Subject: <u>Bid No. 7819-W2, EVSE Installation - Garages / S & R</u>

**ADDENDUM NO. 1**

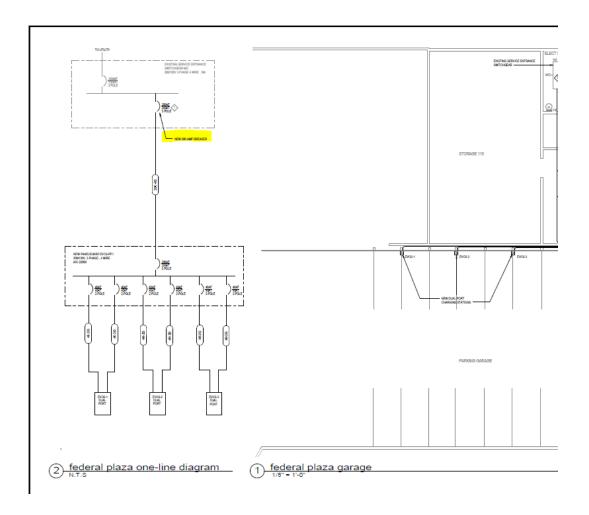
- BID DUE DATE HAS BEEN EXTENDED TO WEDNESDAY, JUNE 8, 2022 AT 10:00 AM
- 1) Federal Plaza Municipal Parking Garage clarification on the proposed 200A frame location. A new 200 Amp Breaker will be required (see Electrical Plans and Specifications note on EP-105), by tapping into the busbar and installing a 200 Amp disconnect with an enclosed circuit breaker on the wall next to the switchgear. The new panel board would then be fed from the enclosed circuit breaker.

Figure 1 Old location in blue and new location in red for the EVCS (Electrical Plans & Specs EP-102)

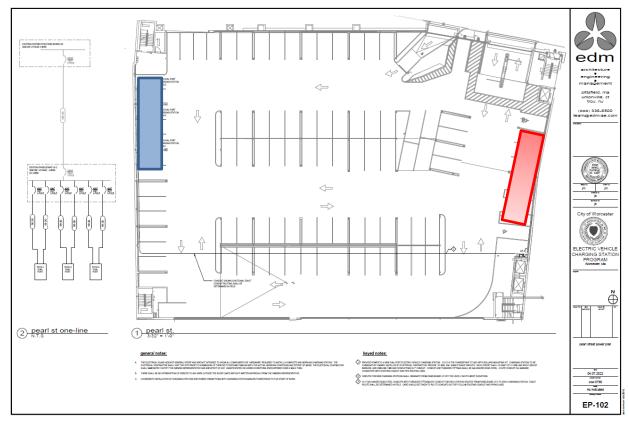
The location of the parking spaces will be closer to the panel board:

Figure 3 Common Garage - location of the existing Schneider EVCS (off Eaton Place) and the general location of the panel board a floor above the actual location (this is P1 level).

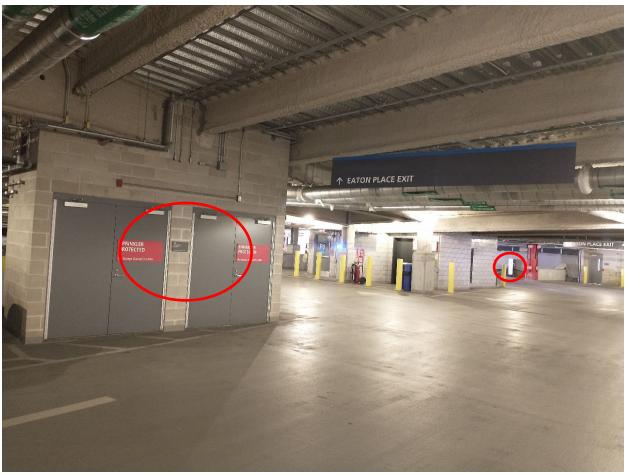
3) **Common Municipal Parking Garage** – the feed to the existing station is shown on Electrical Plans and Specifications, EP-103. Clarification – the Panel board R2P2a is located on the floor P2 of the garage, immediately a floor below the one noted on the plan (highlighted), not above.
